NEW GENERATION TECHNOLOGIES AND GB GRID CODES

**REPORT ON CHANGE PROPOSALS TO THE GRID
CODES IN ENGLAND & WALES AND IN SCOTLAND**

Final Report - December 2004

CC.6.3.3 (d) - DC Converter Load/Frequency Characteristic

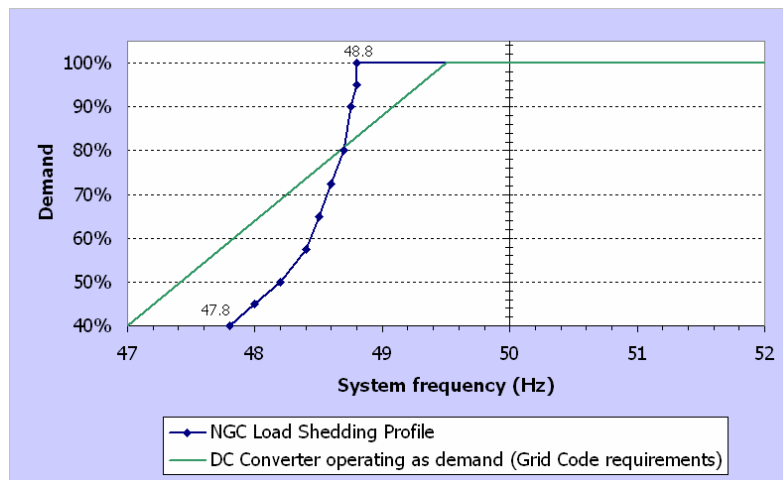
We question the frequency/power input characteristic indicated for DC converters. The following figure shows the proposed HVDC converter performance (when operating as a demand customer)

and the NGC load-shedding scheme⁴. It is clear that the requirements for the DC converters are more onerous for frequency deviations below 49.5 Hz where they are required to reduce demand much earlier than indicated from the NGC load-shedding scheme. Also for frequencies below about 48.8Hz the requirements for DC converters demand are more relaxed than those indicated by the load-shedding scheme. We suggest that the DC converter requirements are approximated to a curve following the NGC load-shedding scheme.

Clause CC.6.3.3 (d) as written allows the DC converter operator to reduce demand, for whatever reason, below the linear relationship (green line) therefore a characteristic approximating to the NGC load-shedding scheme should not disadvantage the DC Converter operator.

CC.A.4.2 – Supergrid Faults up to 140ms Duration

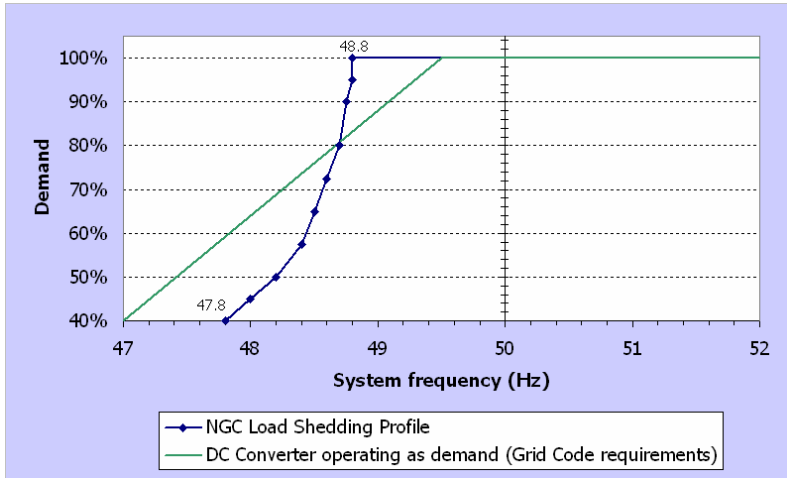
On the Figures (a) and (b) it is not clear what information is meant to be conveyed by the vertical and horizontal arrows - consider removing or possibly indicating the fault clearance time with an arrow. The busbar voltages should indicate 400 kV or 275 kV.

A.1.2 Comparison of E.oN requirements and NGC proposals

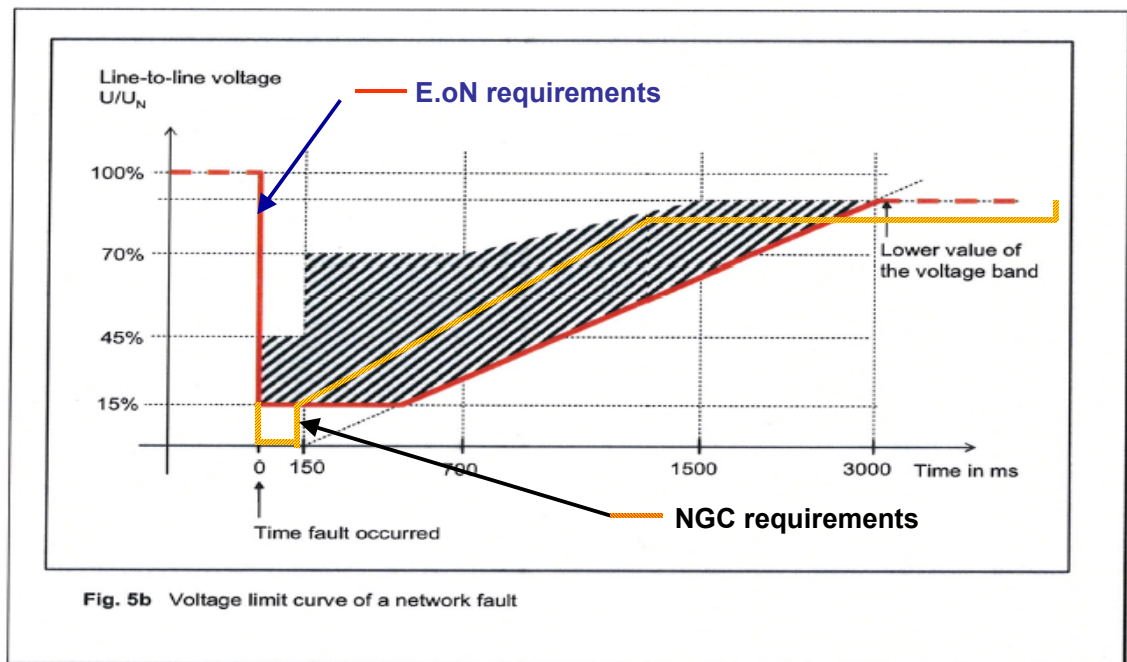
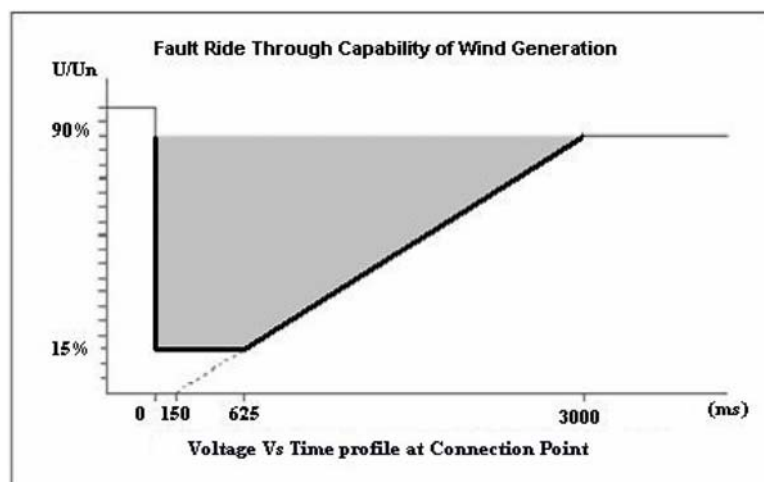
The figure overleaf, which superimposes the NGC proposals (approximated for clarity) onto the E.oN voltage limit curve, shows two main differences namely the more onerous NGC requirement to ride through voltage depressions down to zero (against 15% in the case of E.oN) and the more onerous E.oN requirement with regard to the duration of voltage dips (red line below NGC line in figure overleaf). These issues are reviewed below.

NGC grid code change proposals require the generator to be able to “ride through” voltage depressions down to zero at the **Supergrid** connection point (400 kV and 275 kV), in contrast to the E.oN requirement of 15 percent voltage at the **network** connection point (60 kV and above).

It should be noted that the E.oN Grid Code requirements apply at extra high voltage (220 kV and above) and high voltage (60 kV to 110 kV) network connections. In contrast the NGC requirements apply only at the Supergrid 400 kV and 275 kV connection points, with the implication that plant which is connected at 132 kV or a lower voltage is not required to demonstrate a capability to ride through “zero voltage” at its network connection point. Relatively simple calculations indicate that voltage depressions at 132 kV and lower voltage connection points for zero voltage faults at the Supergrid network are likely to be somewhat above the E.oN requirements.

A further difference between the E.oN Grid Code and the NGC proposals is the rate of rise of electrical power following fault clearance and system voltage recovery. NGC require immediate power recovery (within 1 second) whereas E.oN require recovery gradient of at least 20% of the rated output power per second (i.e. within 5 seconds). We consider that the E.oN power recovery

gradient can be more relaxed than the NGC requirements since E.ON forms part of the UCTE system with an installed capacity of about 550 GW where the requirement to recover power output will not be so urgent as the NGC system requirements with an installed capacity of 76 GW. The one second allowance for the restoration of power to 90% of following restoration of voltage to normal operating range is within the capabilities of modern unconventional generation.

A.2.3 Comparison of international practice with the proposals of NGC

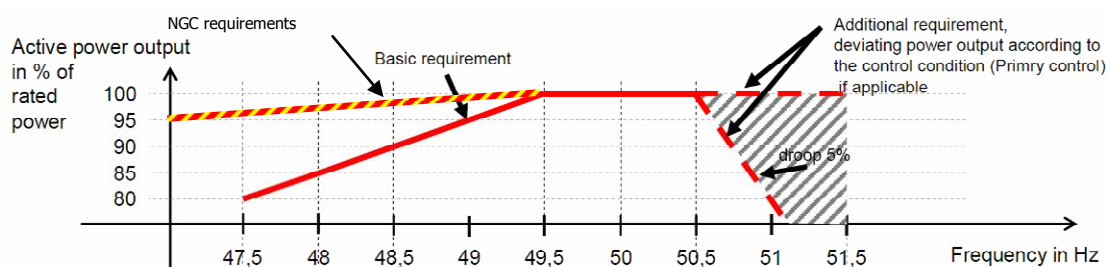
The following figure superimposes the E.oN requirements with the NGC proposals. It shows that in both cases the capability of delivery of full output applies over the same frequency range namely from 49.5 to 50.5 Hz. However the power output requirements in NGC proposals are more onerous for frequencies below 49.5, which require up to 95% output at 47 Hz (proportional to frequency), compared to the requirements of E.oN which allow a reduction in maximum output at 47.5 Hz to 80% of rating. This can be explained again by the relative size of the UCTE system compared to the systems in GB and the likelihood of disturbances that will affect system frequency in a relatively small system such as GB compared to the UCTE.

A similar comparison can be undertaken with the Irish Wind Grid Code. In this case a quantitative comparison cannot be made as the points in the power/frequency curve may vary for each wind farm. It is noted that the requirements in the Irish Wind Grid Code can be more onerous than those indicated in the NGC proposals and may be explained by the relatively small size of the system in Ireland the likelihood of larger generation / demand unbalances following system disturbances and the importance of generator performance under those conditions.

A.5.3 Comparison with the proposals of NGC

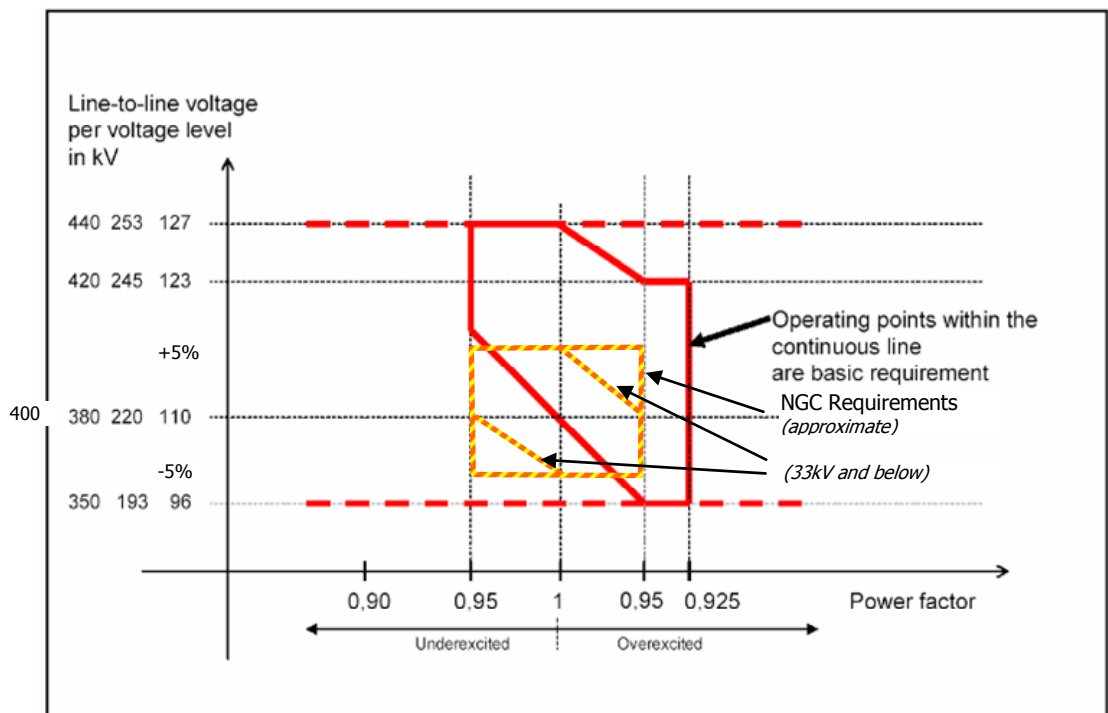
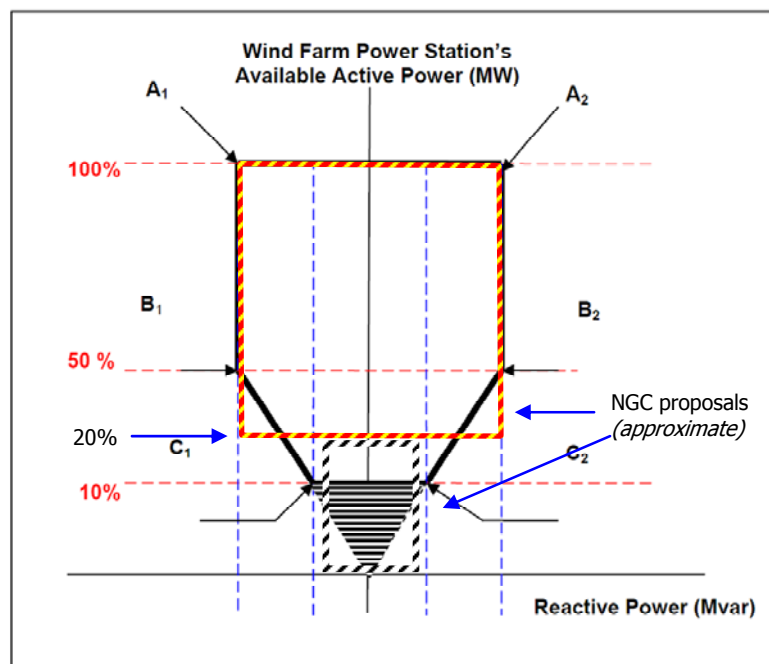
For wind farms below 100 MW the requirements of E.oN and NGC are identical within the range of normal operating ranges in each jurisdiction. However a relaxation of requirements for wind farms connected at 33 kV and below is indicated in NGC's proposals that assume the lack of tap changing transformers which is considered reasonable. For wind farms above 100 MW, the following figure shows the E.oN requirements for reactive power control and superimposed the proposed NGC requirements. The figure shows the NGC requirements for generators connected above 33 kV (square hashed line below) and also the requirements for generators connected below 33 kV (lines indicated in the figure below). For comparison purposes only the requirements above 33 kV are valid as the E.oN requirements shown in the figure (red line) only apply for wind farms above 33 kV.

The comparison of the outline curves in the figure indicates that the E.oN "basic requirement" is more onerous than NGC's in terms of maximum operating voltage and power factor (overexcited) and indeed the possible maximum requirement (dashed red line). It should be noted that the E.oN requirement includes normal operating conditions and transient overvoltages (up to 30 min, in the graph the area above the 420/245/123 kV dotted line) NGC proposals are more onerous in the case of E.oN when voltages are below nominal and the machines are required to be able to operate under-excited. However it should be noted that there are different requirement philosophies in the

E.ON grid code and NGC proposals. The E.ON basic requirement is a “minimum” requirement that can be further expanded (within the dashed red lines shown in the figure above). The NGC requirement is a “maximum requirement” that could be reduced in the connection agreement. As such it can be concluded that the NGC requirements for large wind farms (>100 MW) are completely within E.ON possible range of requirements.

The following figure shows the NGC proposals superimposed against the requirements in the Irish Wind Grid Code. The main difference between both requirements is that the relaxation of the reactive power requirements in Ireland starts to drop for wind farm outputs below 50% compared to 20% in the NGC proposals. However it is not considered that this difference is relevant as with a 20% wind farm output it can be expected that all wind turbines will be connected to the network and hence its reactive capability would remain intact. Typically it can be expected that individual wind turbine generators will start to trip when the wind farm output gets around 5%.
